**PROPOSED COMMERCIAL DEVELOPMENT
ROANOKE, ROANOKE COUNTY, VIRGINIA
UTILITY PLAN**

**DRAWING NUMBER
24-03**

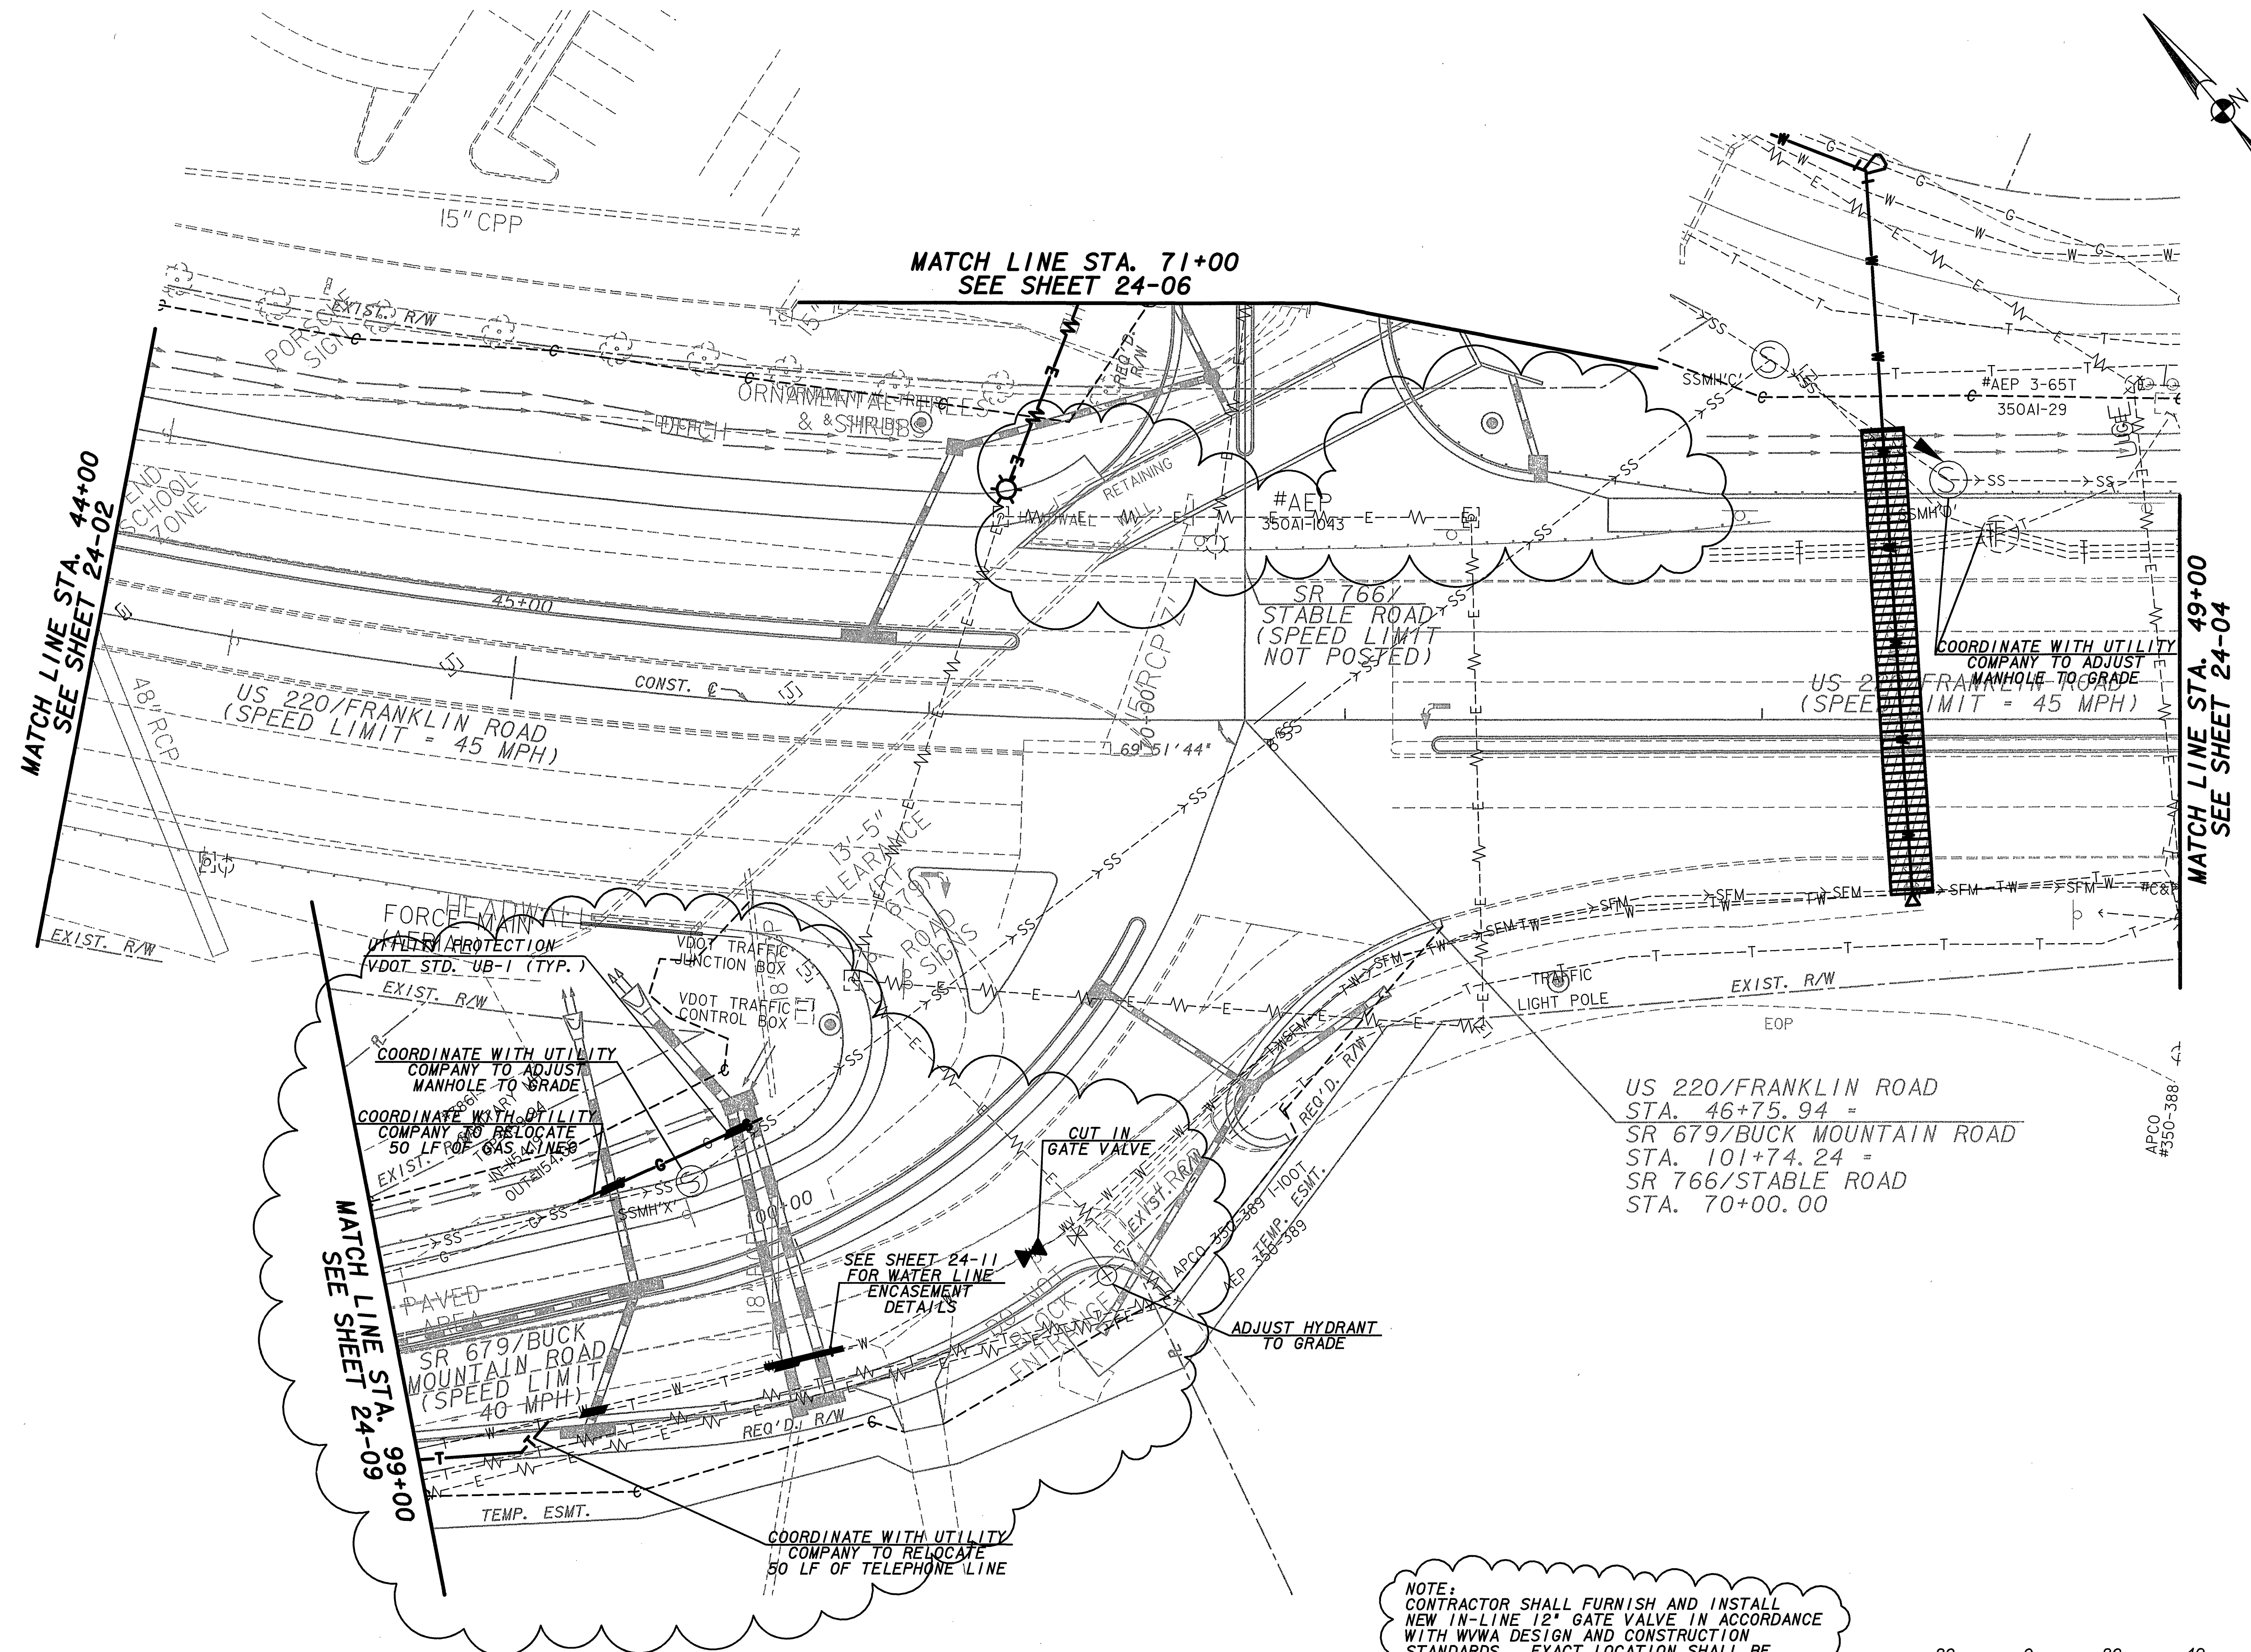
NOTE:
CONTRACTOR SHALL FURNISH AND INSTALL
NEW IN-LINE 12" GATE VALVE IN ACCORDANCE
WITH WWA DESIGN AND CONSTRUCTION
STANDARDS. EXACT LOCATION SHALL BE
DETERMINED IN FIELD WITH WWA
CONSTRUCTION INSPECTOR.
